## **SICHERHEITSMITTEILUNG** **für Gurtzeuge**

Nummer: 2026-05 SM Paraworld – Sife - Klappe Rev. 1

## Service Bulletin 2023-001 Revision 1

**Subject: bar tack/zig zag stitching on main container flap #2**

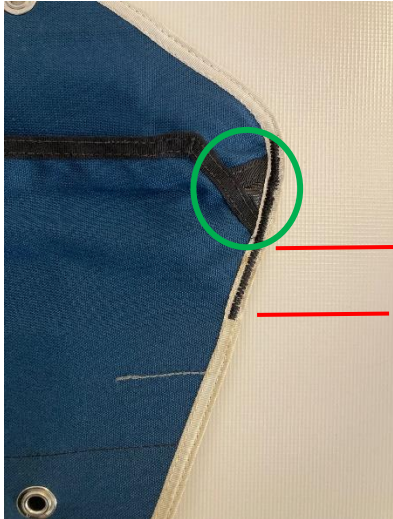
### 1. Stitching between the two red lines

If the material is weak between the two red lines on the picture below, we recommend strengthening the main container flap #2 with a bar tack/zig zag stitching (minimum 10 stitches per inch, 3mm wide). Start at the end of the binding, where the flap is attached to the reserve container and end at the beginning of the stiffener (red lines in the picture below). You may overstitch your bar tack/zig zag stitching. The result of the stitching is a stiff flap in this area.

### 2. Stitching between the green circle

The flap #2 is stiff in the area between the two bindings (green circle on the picture above), when your SIFE rig comes out of production because of a stiff material and a stitching under the bindings. If the material and/or the stitching under the bindings are weak after many jumps (green circle in the picture above), overstitch this area also with bar tacks/zick-zack stitching (minimum 10 stitches per inch, 3mm wide).

The result is a stitching, which begins over the first binding and ends at the beginning of the stiffener. The result of the stitching is a stiff flap in this area.

You don't have to separate the flap from the reserve container while doing the bar tacks/zig zag stitching.

Check the stitching and the material of the flap #2 (between red lines and green circle) on each reserve repack.

If the flap #2 stays weak between the red lines and/or the green circle after your stitching, we recommend contacting SIFE and ordering a new center flap. See prices on [www.sife.at](http://www.sife.at)
